# EHPA Position Paper

EHPA's written comments on the draft Regulations (EU) 813/2013 & (EU) 811/2013 for space heaters and combination heaters – Review ENER Lot 1

- PRODUCT 1 : As an Integrated combination heater : A thermally driven heat pump + an auxiliary boiler

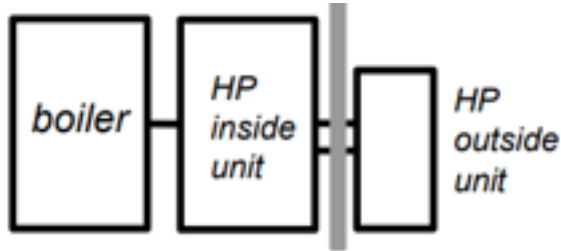
EHPA would recommend that the European Commission to clearly include these solutions in the regulations.
